AMENDMENTS TO THE DRAWINGS:

FIG. 2

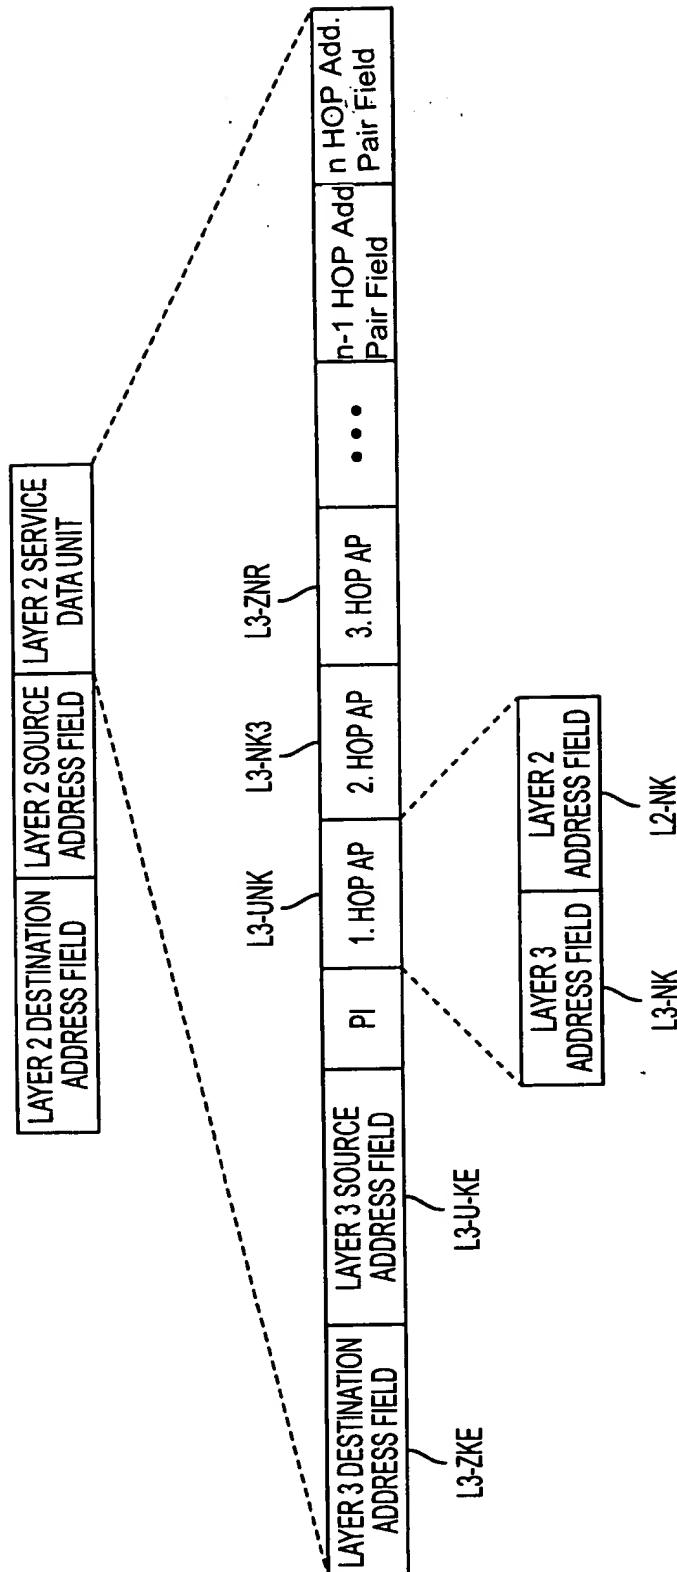
The attached drawing includes changes to FIG. 2. The sheet containing FIG. 2 replaces the original sheet including FIG. 2. In FIG. 2, labels have been added to address a rejection raised by the Examiner, and for consistency with the specification. For the n-address pair fields represented in the drawings, two additional address pair fields have been specifically shown. As revised, FIG. 2 shows the first, second, third, n-1 and n address per field. The Examiner is referred to the paragraph beginning at page 7, line 2 of the application.
